**ZONING AMENDMENT &
SUBDIVISION STAFF REPORT**

Date: August 21, 2014

1716 Industrial Park Drive, LLC

Industrial Park Two Subdivision
1716 Industrial Park Drive
(West side of Industrial Park Drive, 370'± North of Halls
Mill Road extending West to Montlimar Drainage Canal)

SITE PLAN

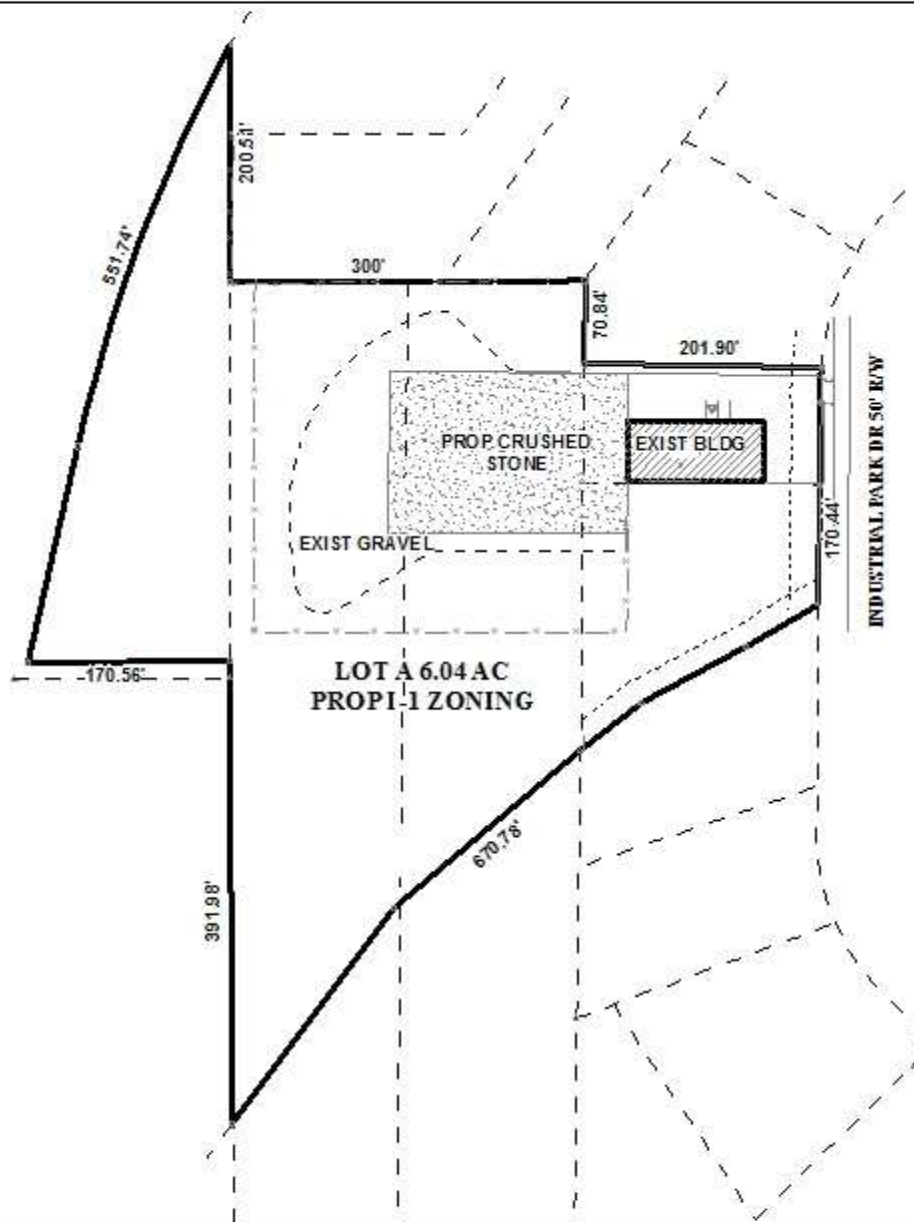
It should be pointed out that the site plan does not depict the location or size of an office for the proposed business nor does it appear to accurately depict the current site conditions as it relates to impervious surfaces, i.e., the existing paved parking areas on the site. Also, the 2 proposed parking spaces do not appear to contain any bumper stops or curbing nor is an accessible route depicted from the accessible parking space to the building and, although the Planning Section does not enforce accessible parking or ADA, certain aspects of ADA do impact site design. As such, any revised site plan or building plan should include the location and size of an interior office space, if proposed, and comply with Section 64-6. of the Zoning Ordinance, in addition to design compliance with the requirements of the ADA, in accordance to the applicable building code section 1106 (and 2010 ADA Standards for Accessible Design), at the time of permitting.

It should be pointed out that there is no dumpster depicted on the site plan. Any revised site plan should illustrate the location of a dumpster in compliance with Section 64-4.D.9. of the Zoning Ordinance, or a note stating that waste removal will be via curb-side pick-up.

It should be noted that a sidewalk is also not illustrated on the site plan along the street frontages and may be required at the time of any structural expansions of the site.

Lighting is not illustrated on the site plan. Any new lighting on the site will have to comply with the requirements of Sections 64-4.A.2., 64-6.A.3.c., and 64-6.A.8. of the Zoning Ordinance. A note reflecting this requirement should appear on any revised site plan.

The site has frontage along Industrial Park Drive, a minor street with a compliant 50' right-of-way and therefore, no dedication will be required. The site currently has 3 existing curb-cuts on Industrial Park Drive; however, the site plan only depicts 1 substandard curb-cut. Therefore, as a means of access management, the site should be limited to one curb-cut, with any changes to the size, design and location to be approved by Traffic Engineering and conform to AASHTO standards.

It should be pointed out that the site plan and plat depict a 20' drainage and utility easement. If approved, the Final Plat and site plan should be revised to include a note stating that no permanent structures can be constructed in any easement.
